STAFF RECOMMENDATION
2616 Belmont Boulevard
April 17, 2013

Application: New construction-addition
District: Belmont-Hillsboro Neighborhood Conservation Zoning Overlay
Council District: 18
Map and Parcel Number: 11704012500
Applicant: Michael Ward, architect
Project Lead: Robin Zeigler, robin.zeigler@nashville.gov

<p>Description of Project: The applicant proposes construct an addition to the house at 2616 Belmont that will include an attached garage and utilize an existing shared driveway.</p> <p>Recommendation Summary: Staff recommends approval of the partial-demolition and addition with the condition that staff approve the roof color, trim material, and the final door and window specifications. With this condition, staff finds that project meets the applicable design guidelines for the Belmont-Hillsboro Neighborhood Conservation Zoning Overlay.</p>	<p>Attachments A: Photographs B: Site Plan D: Elevations</p>
--	--

Left rear corner of house. Exterior staircase will be removed.

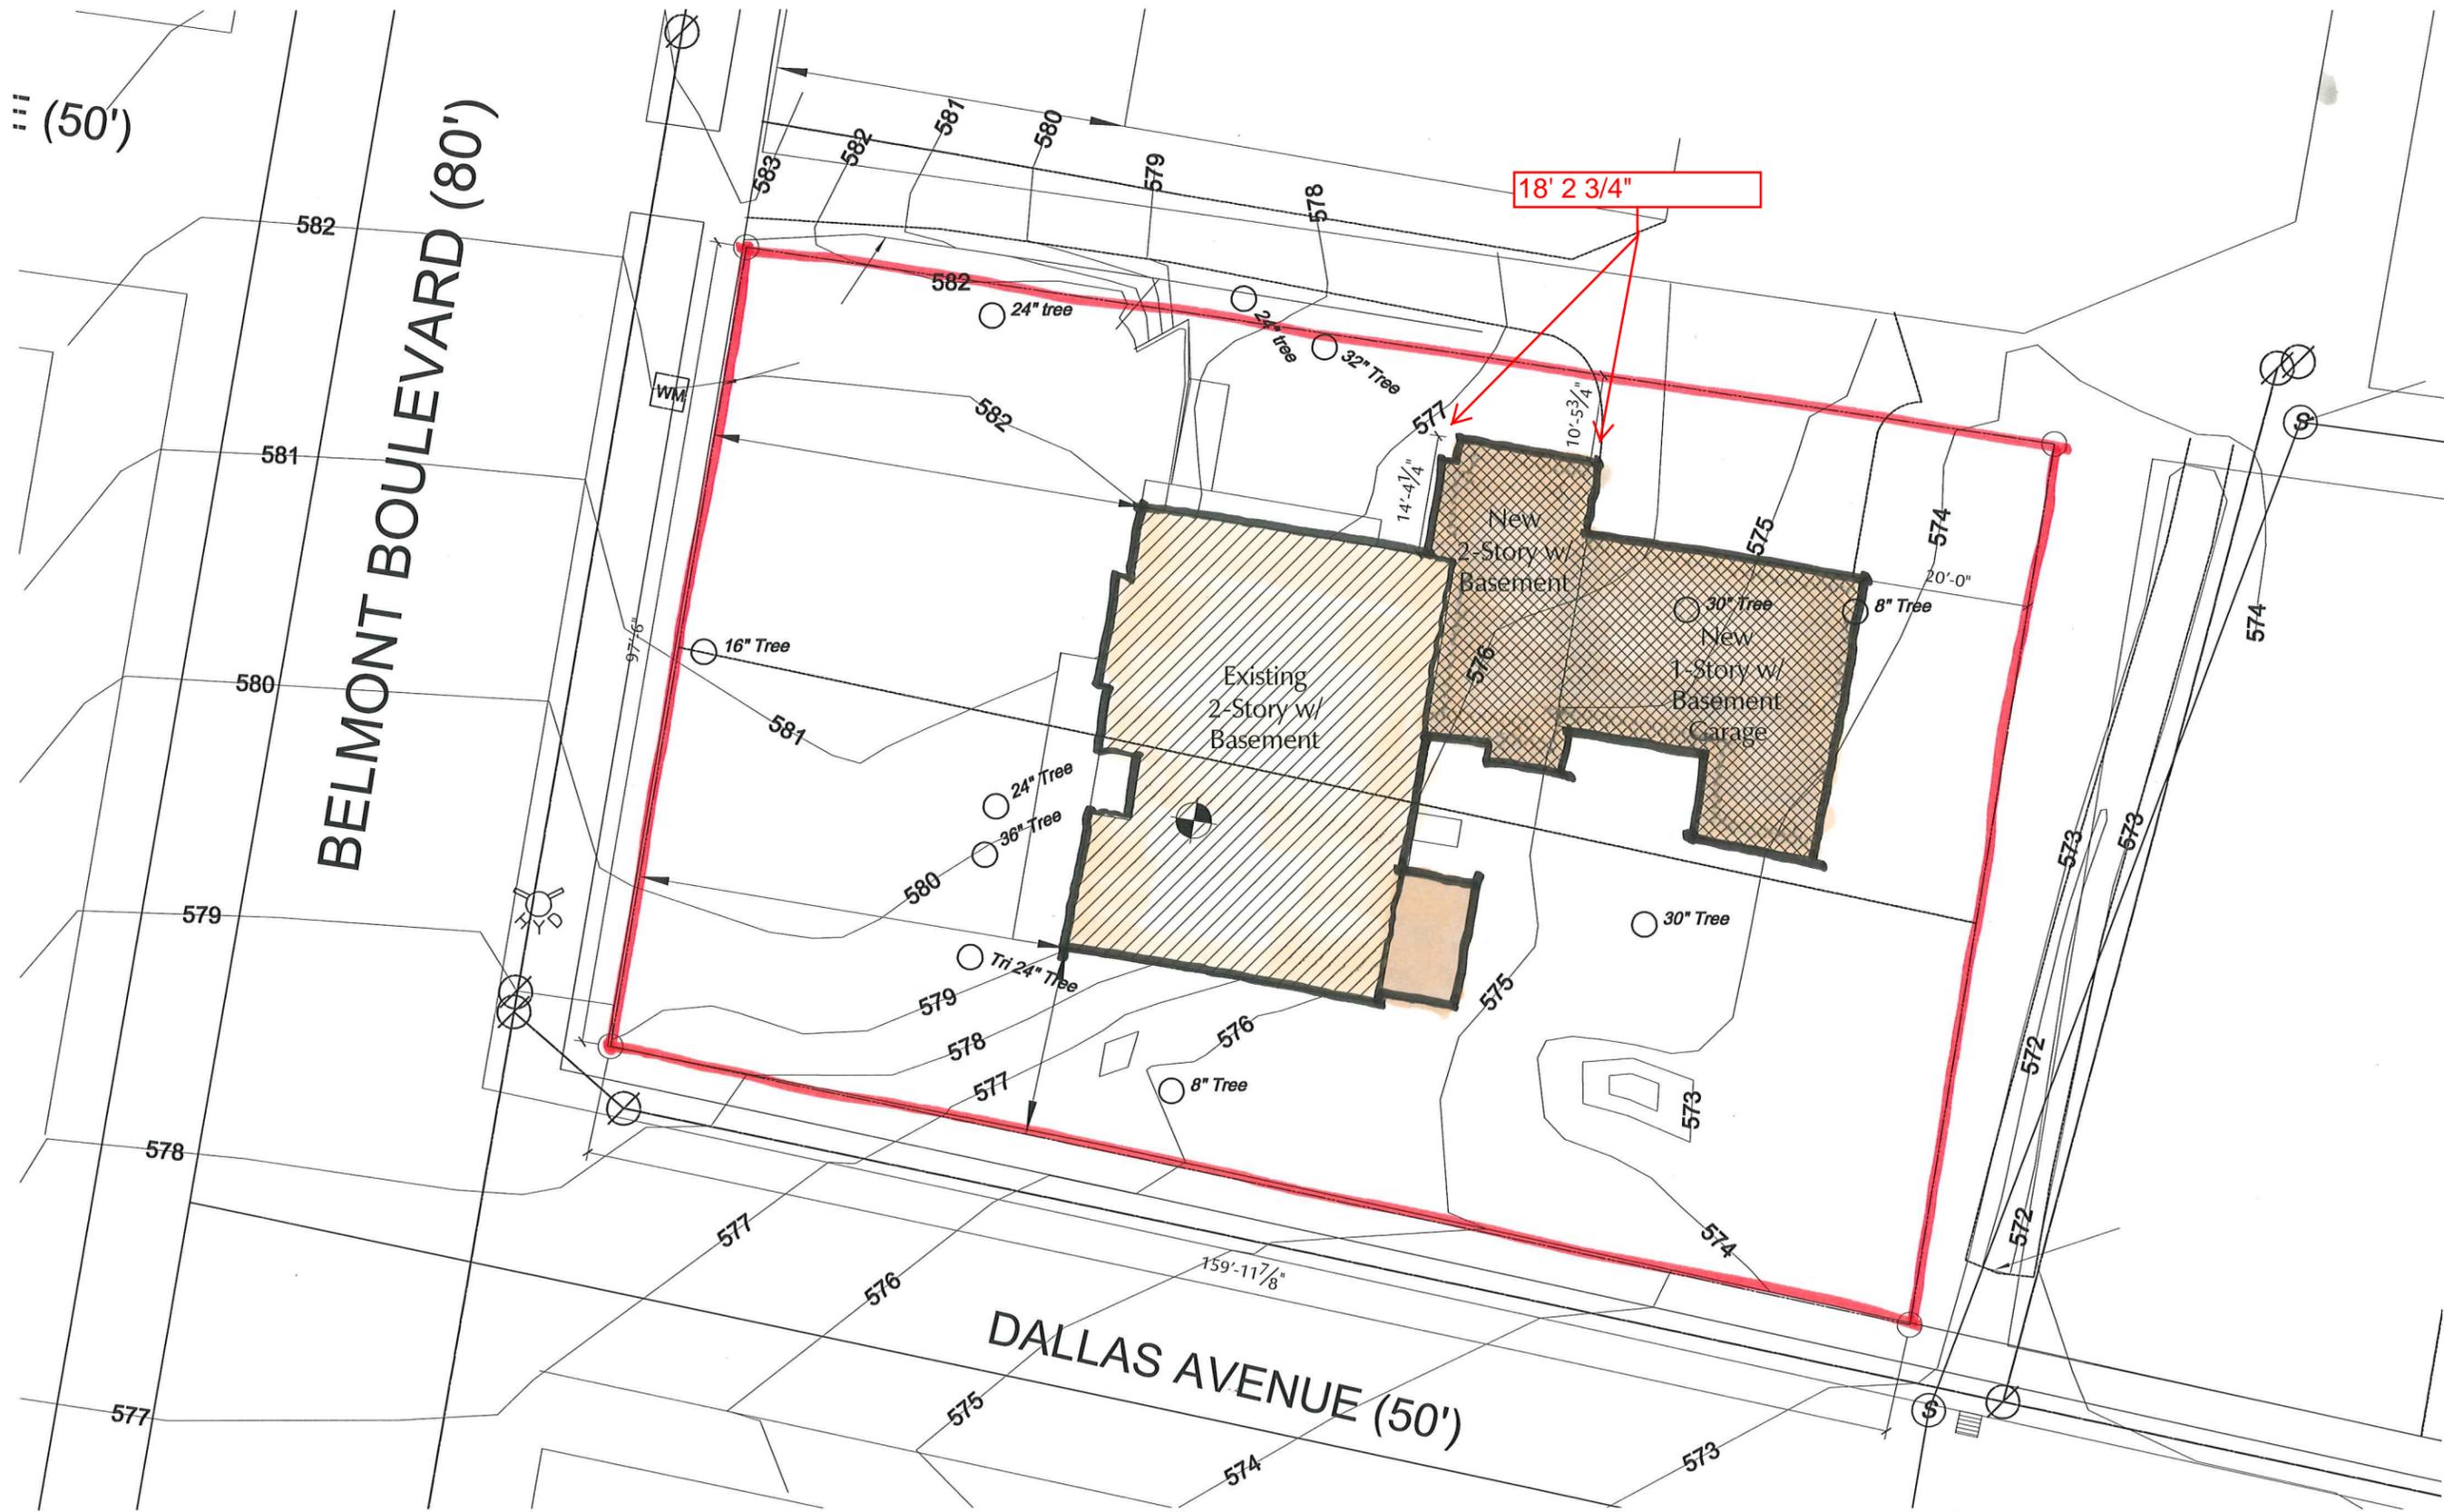
Partial Demolition: The project requires the removal of an exterior staircase on the left side of the house. The stairs are not original or historic so their removal meets section III.B.2.b.
